DOCUMENT CHANGE REQUEST

DCR number 488 Changes required for: General
Date: 2009/04/14 Date sent: 2009/04/14
Status: IMPLEMENTED

Title: Transistors Low Power NPN, based on type 2N2219A

Number: 5201/003 Issue: 2

PHYSICAL DIMENSIONS AND TERMINAL IDENTIFICATION

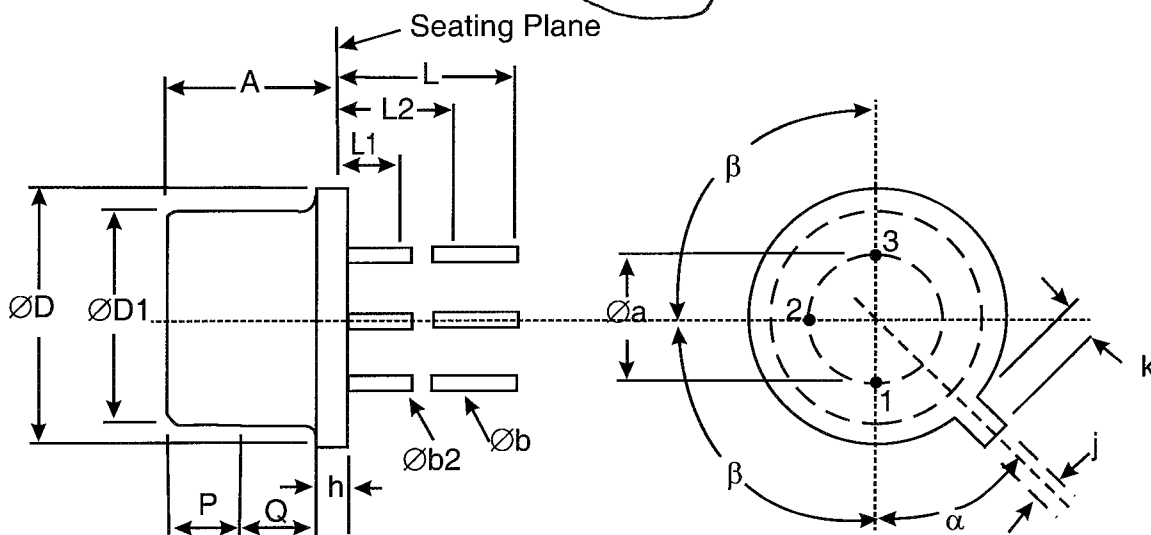
see attached

, and any handling,

no spaces ie (TO-39)
